September 8, 1992

Dear Range Owner,

We wanted to write and share some safety features that we have added to our batting ranges. Please read this material carefully.

figure 1.0

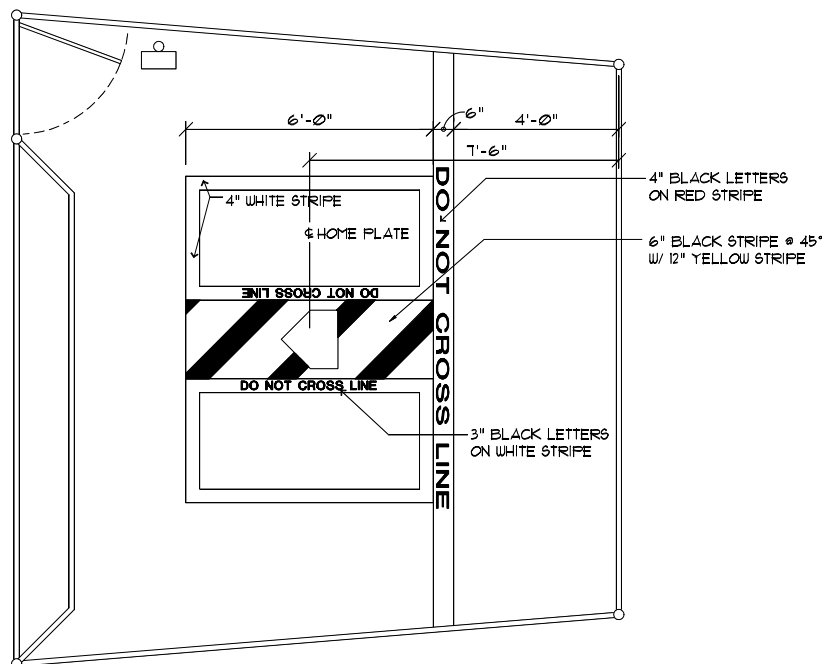
The illustration below (figure 1.0) is an overview of a typical batting stall and batters box. Please note the 7'-6" dimension from the opening of the stall to the center of Home plate. This dimension will ensure the "Batters Box" is adequately back far enough from the opening of the stall and reduce the risk of "fouled balls" striking another batter. If your Batters Box is not at least 7'-6" as shown, you will need to move your boxes back.

Also note that we suggest you paint a red "**DO NOT PASS RED LINE**" line as shown on this drawing. The purpose of this line is to keep customers from going forward of this line. We clearly do not want customers out in "open" area, in the "pit", or batting in an area which will cause the flight of the ball to enter another stall.

Please implement these changes or additions for the stalls immediately. If you have any questions please call ABC.
